Picton Road upgrade between Nepean River and Almond Street, Wilton

REF submissions report
November 2024

Figure 5-1 Overview of the revised proposal

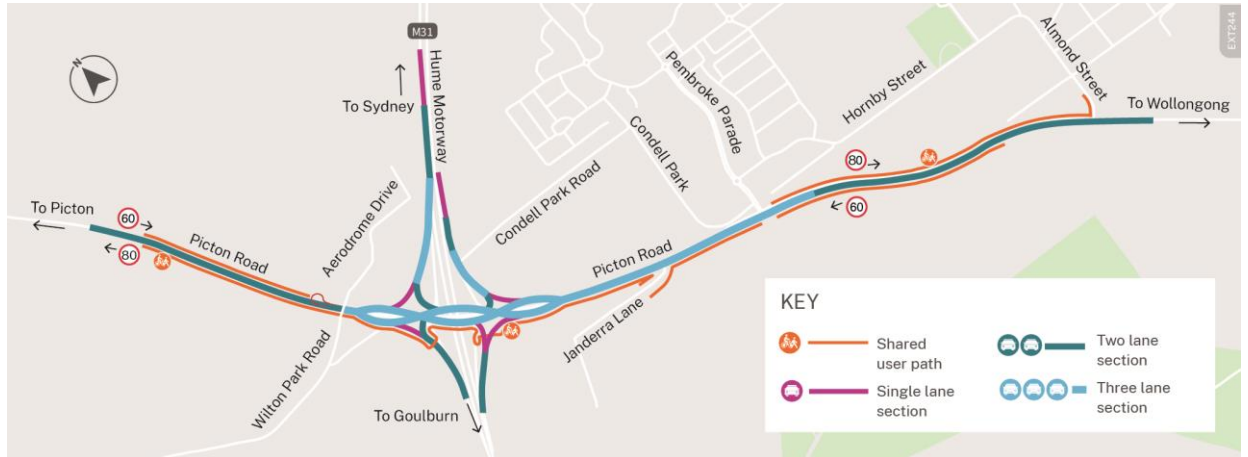
In response to submissions and following further design development, a number of changes to the REF proposal were identified. These changes are shown in Figure 5-1 and described in the following sections. Environmental assessments, where required, are provided in section 6.

Figure 5-2 Additional (second) lane on M31 Hume Motorway northbound off ramp

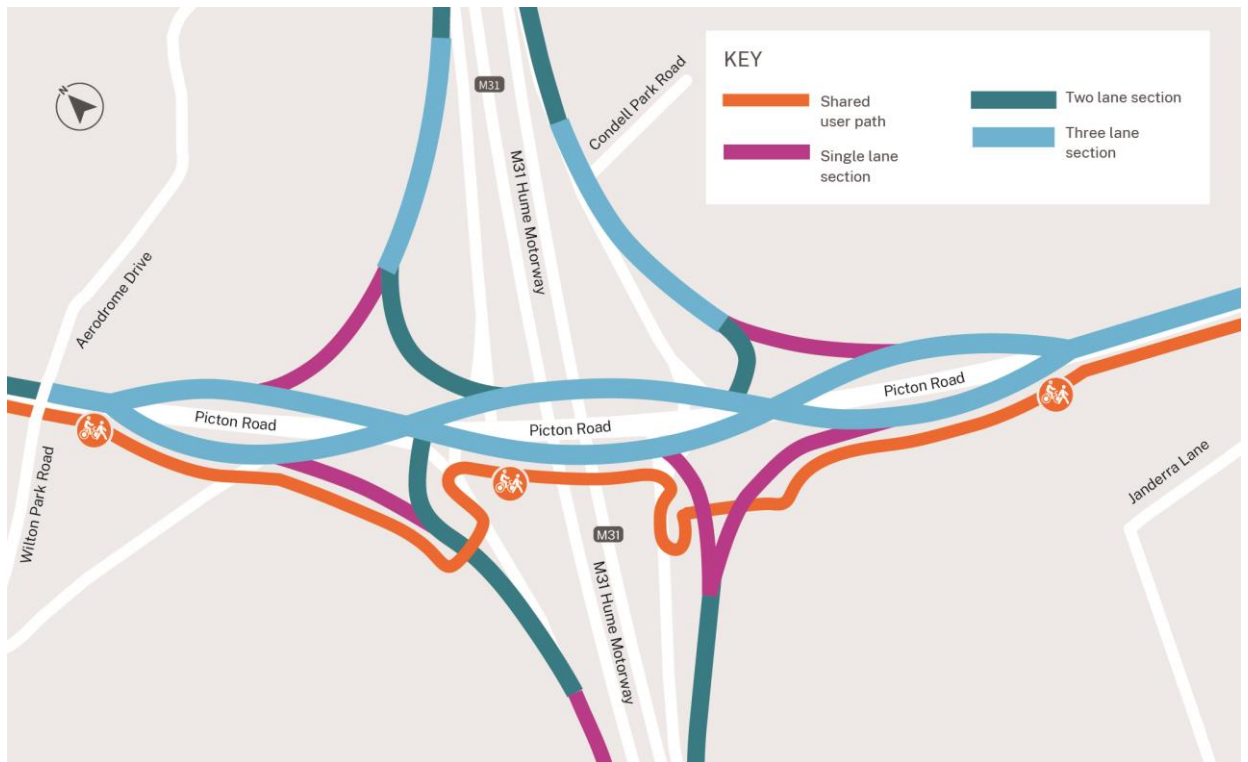
Further design development following public exhibition of the REF has identified an opportunity to provide an additional right turn lane at the interchange of the northbound off-load ramp from the M31 Hume Motorway and Picton Road, as shown in Figure 5-2. This change to the proposal would provide more throughput capacity for vehicles exiting the M31 Hume Motorway and travelling eastbound towards Wollongong and minimise the potential for vehicle queues extending south on the off-load ramp and potentially onto the M31 Hume Motorway. The additional lane would also provide additional capacity to manage incidents at this ramp.

This arrangement is a permanent arrangement and would be constructed as part of Stage 1 of the proposal. A traffic assessment of the proposed changes is presented in section 6.2 of this report.

Figure 5-3 Reduction in impacts on avoided land

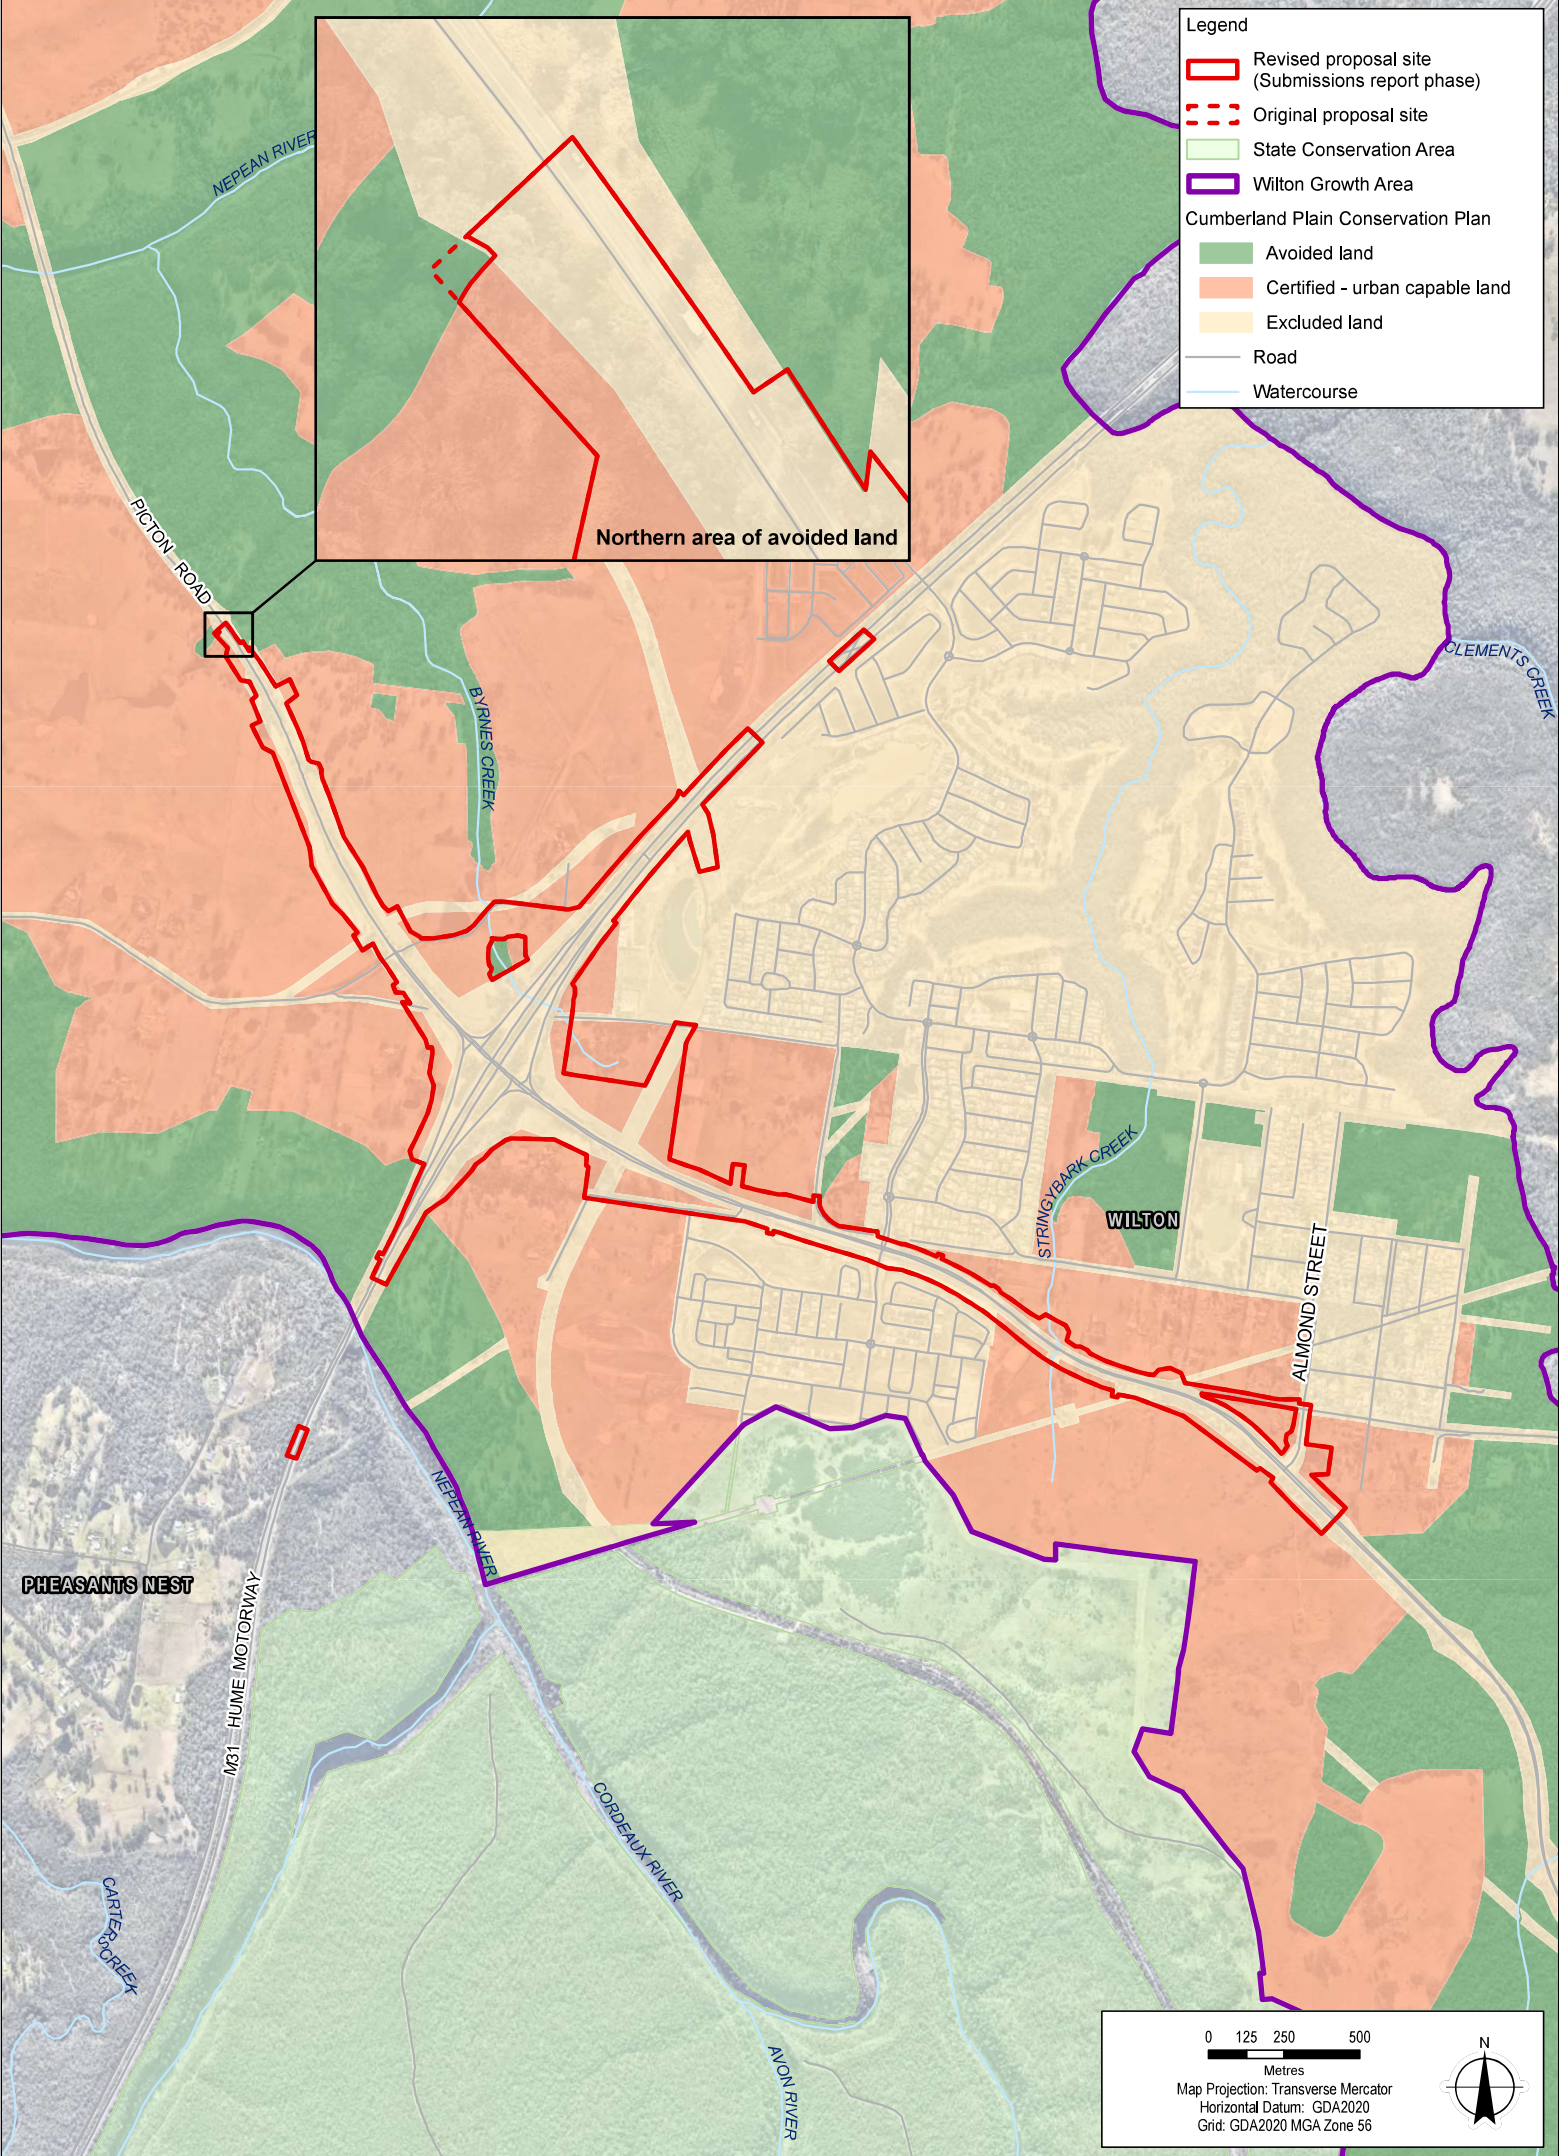
Optimisation of the drainage design for the proposal has meant that the potential impacts to 144 square metres of ‘avoided land’ mapped under the Cumberland Plain Conservation Plan have now been removed from the proposal scope. Realignment of the drainage channels at the western extent of the proposal on Picton Road has meant that these channels, which would take clean water and water discharged from the water quality basin, can now be contained within either the Excluded land (i.e. road corridor land) or Certified –urban capable land mapped under the CPCP. The amended proposal site is presented in Figure 5-3.

Figure 5-4 Channelised right turn at Almond Street intersection

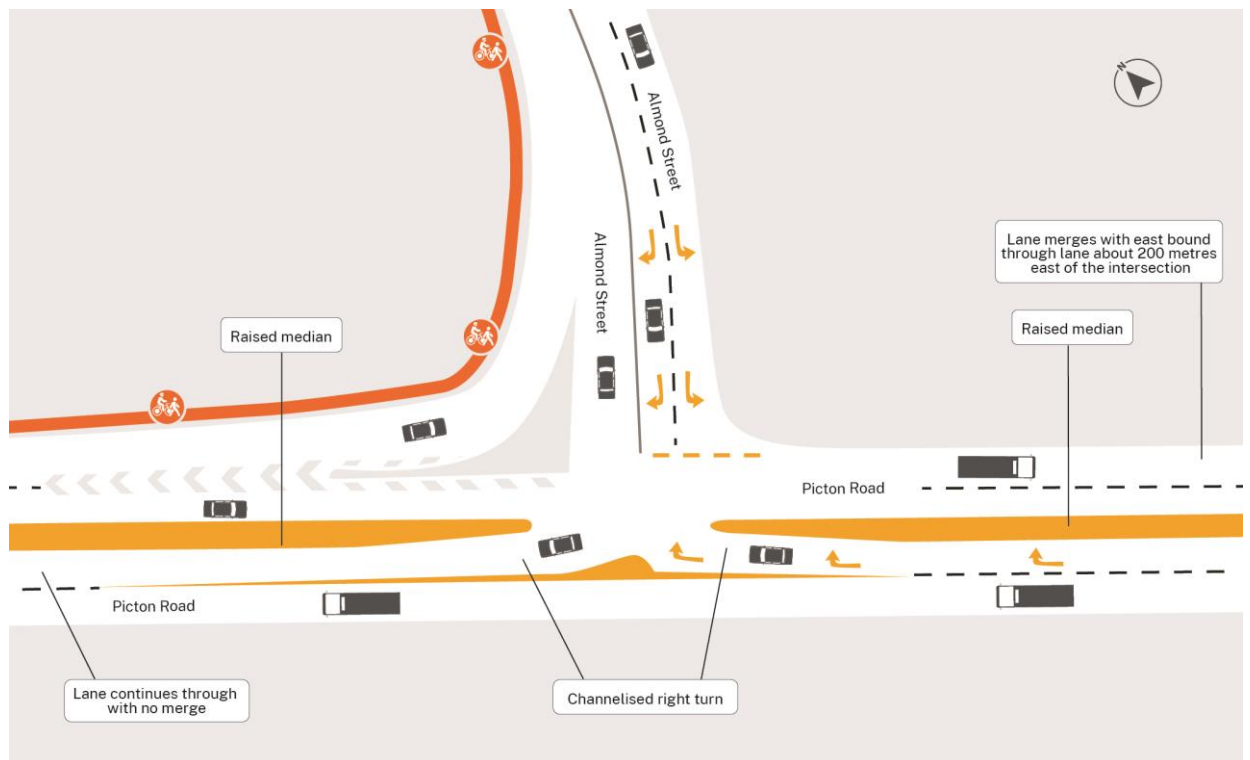
An opportunity was identified to provide channelised right and left turn lanes off Picton Road for vehicles entering Almond Street and a separate lane for vehicles turning right out of Almond Street to travel westbound, as shown in Figure 5-4. This would provide safer movements for motorists and would remain in place until the developer-funded Almond Street interchange is constructed.
